**ADDENDUM #5
NWIT-13-17
4th Street Pedestrian Overpass
New Westminster, BC**

Date: August 8, 2013 File: 20132297
To: Keith Whiteley, A.Sc.T.
From: Craig Schaper, P.Eng.
Project: 4th St Ped Overpass
Subject: Tender Addendum 5

This Addendum forms part of the Bid Documents and amends the original Contract Requirements, Specifications, and Drawings.

CITY OF NEW WESTMINSTER
STRUCTURAL
STEEL FRAMING - SHEET 1

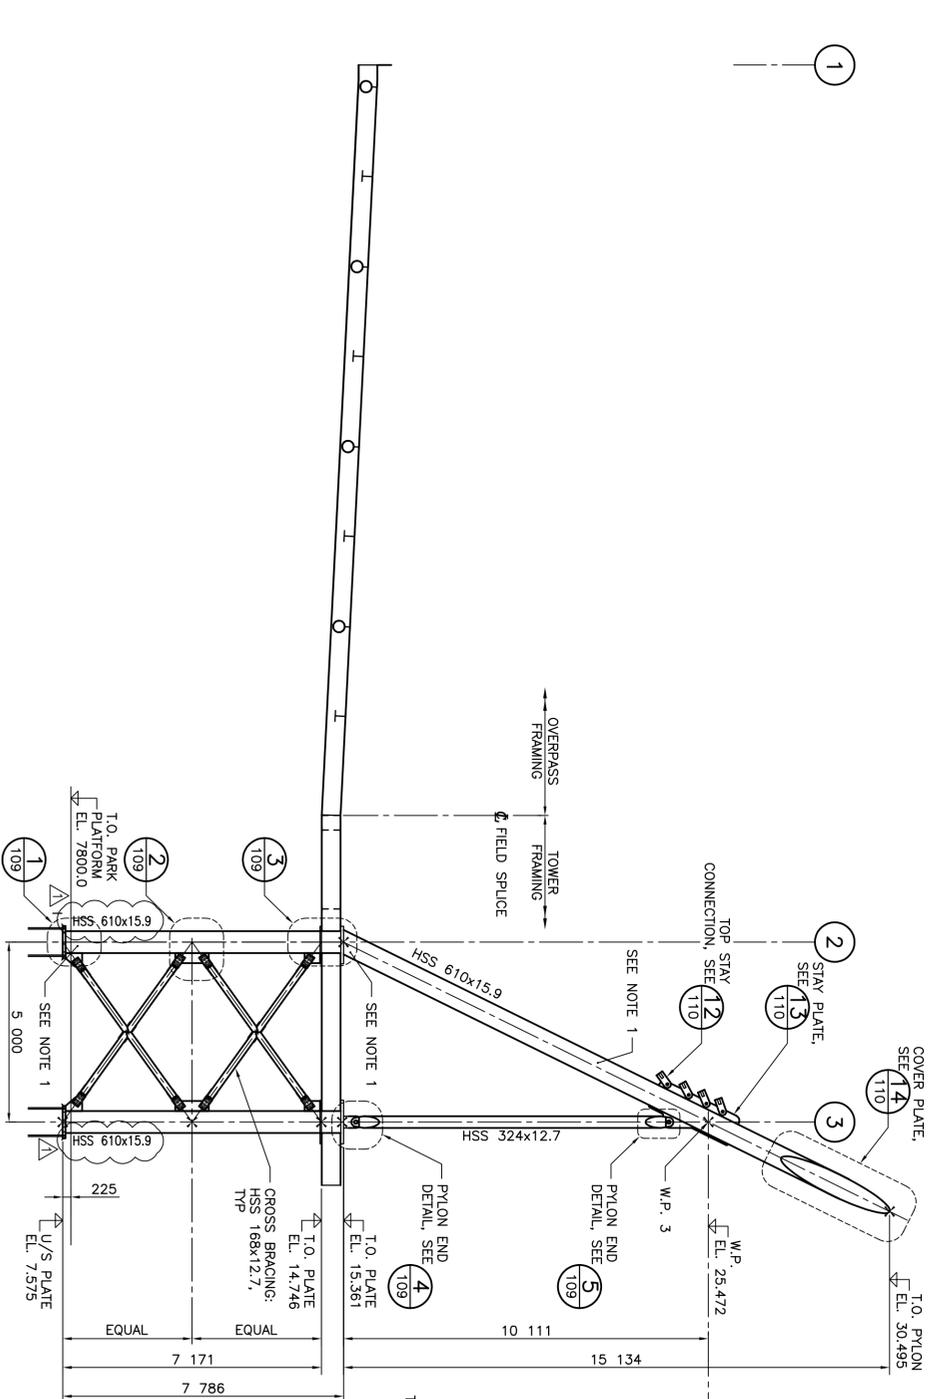
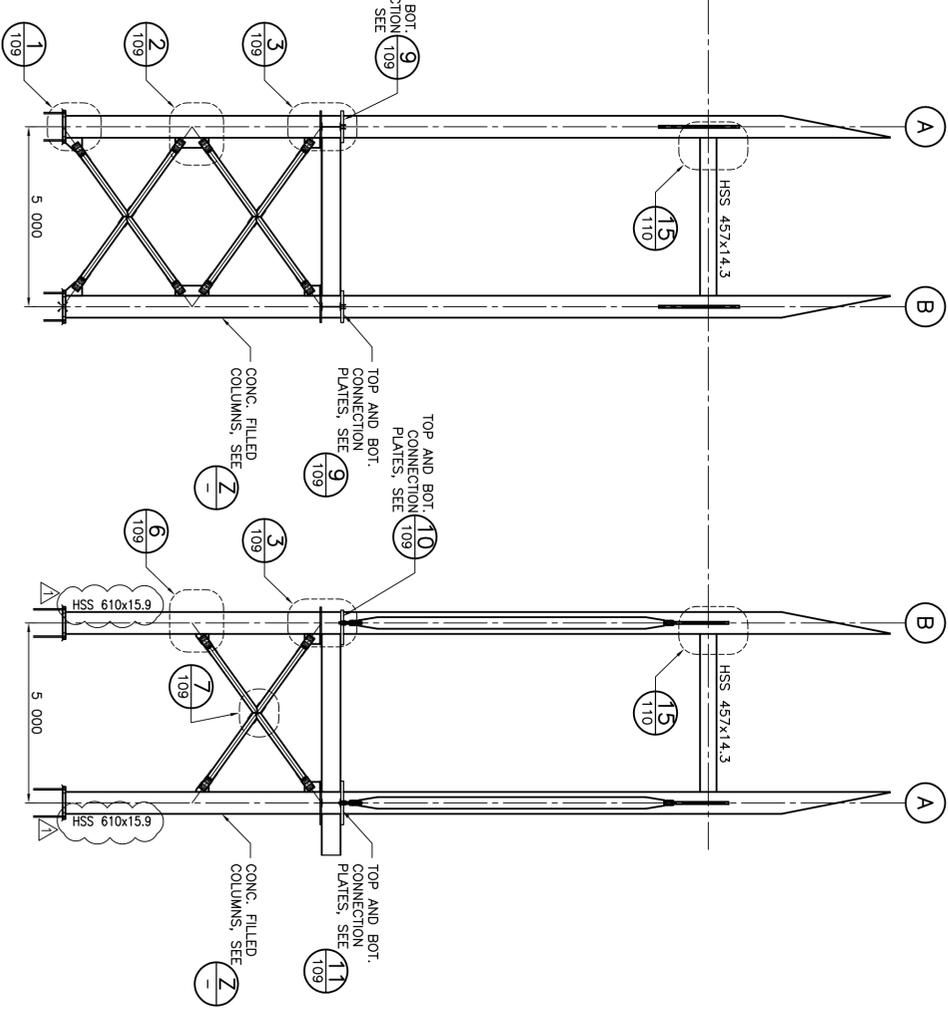
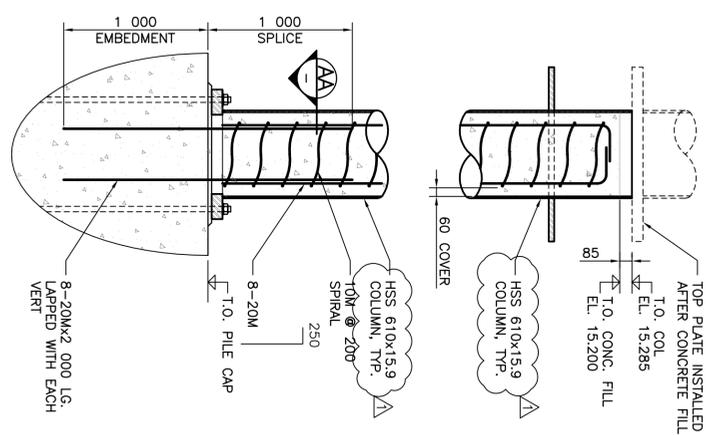
- Q2. Drawing 2297-104 rev. 1 calls out the column size as HSS 610x15.9, while drawing 2297-108 calls out the column size as HSS 610x12.7. Please confirm which governs?

NO.	DATE	ENG.	BY	SUBJECT
1	2013-06-28	C.S.	K.B.	ADDENDUM 5 - COLUMN SECTION CALL OUT CORRECTED
0	2013-06-21	C.S.	K.B.	ISSUED FOR TENDER

- R2. The column size should be HSS 610x15.9. Drawing 2297-108 (Rev 1) has been corrected to remove this discrepancy, and is included as part of this addendum.
